**ATTACHMENT 11.1.3**

**AMENDMENT NO. 2 – SHIRE OF CUNDERDIN LOCAL PLANNING SCHEME NO. 4**

**Subject:** Request for Comment - Amendment No.2 - Shire of Cunderdin Local Planning Scheme No.4

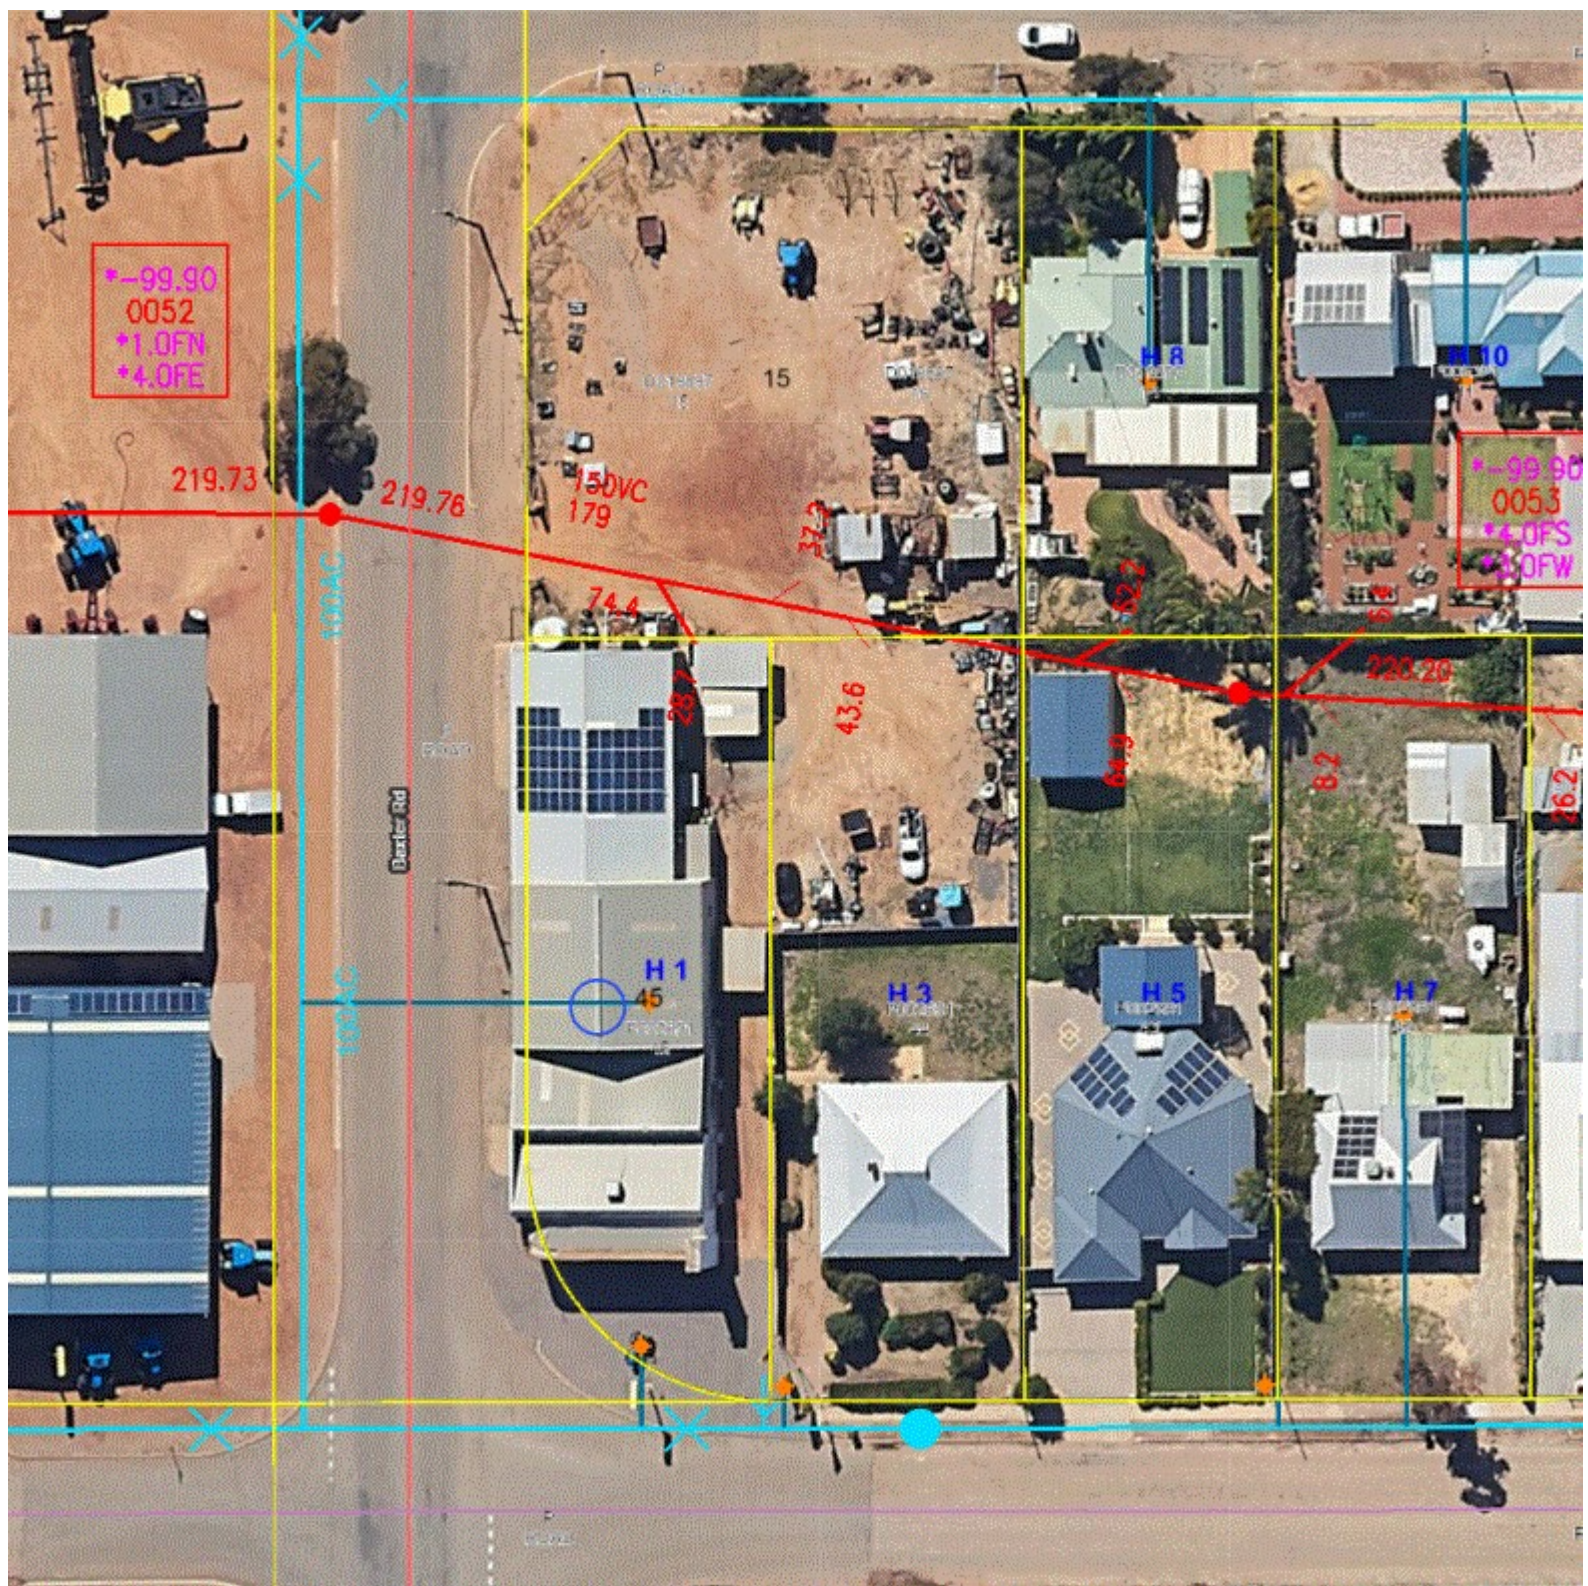
For reference purposes, I have attached a screenshot of the existing water and sewer pipes around the site. Future redevelopment, particularly on No.3 Main Street, will need to be adequately set back from the existing gravity sewer that runs on a diagonal alignment inside the rear boundary of the property. The landowner can obtain further advice from us about the sewer at the appropriate time prior to submitting a building application.
